2021-2026 Victorian Electricity Distribution Price Reset

Summary of engagement with Victorian
Community Organisations

May 2020

**Brotherhood
of St Laurence**

Figure 10 Solar constraints by zone substation (percentage of daylight hours)

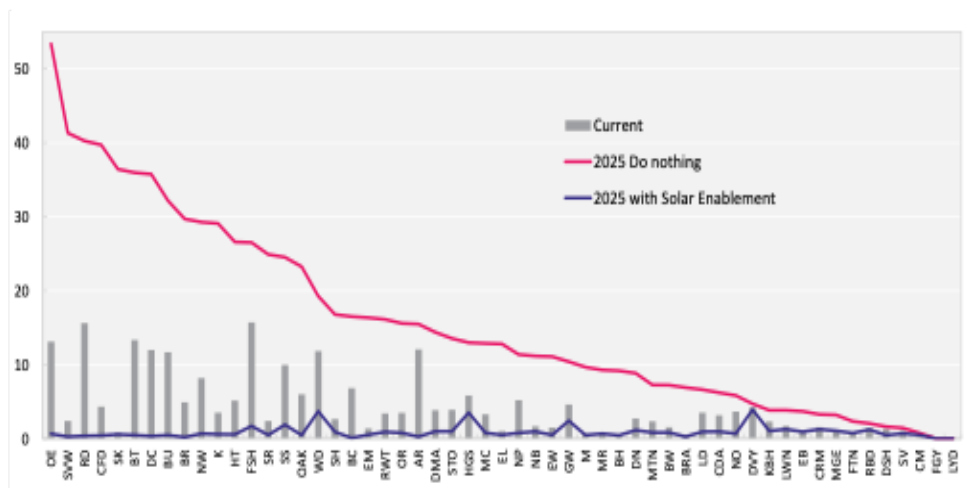
1. In point 5.2.2 of the Solar Enablement business case, you explained that the DVMS (dynamic voltage management system) would allow a greater amount of solar PV to be connected before experiencing constraints. How much does dynamic voltage control increase the PV capacity of a line? If constraints are assumed to occur at 30% penetration normally, at what penetration would they occur if voltage control was implemented (if that is a simplification – are you able to express the extent of improvement in other terms?) Do you have a sense of how the chart below would be impacted for each distributor by rolling out DVMS and dynamic controls, without the augmentation such as transformer and LV asset replacement needed to allow PV to be exported to the HV network?

Figure 3 – Estimated power flows at ZSS based on the pre Solar Homes Package Program (base forecast)

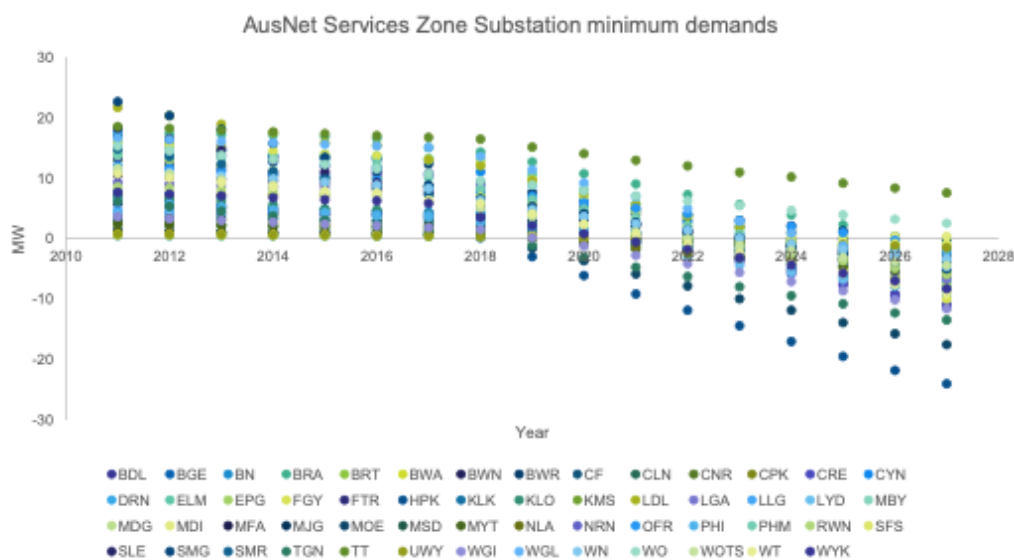
5. The chart below suggests that more than half of the ZSSs will be exporting generated load to the HV network by 2023. This develops very rapidly over the following 5 years so that almost all ZSSs will be exporting to the HV networks at minimum constraint periods.

Much of this export can be expected to occur at the same time.

Will this cause constraint on the HV network? How will this be managed?
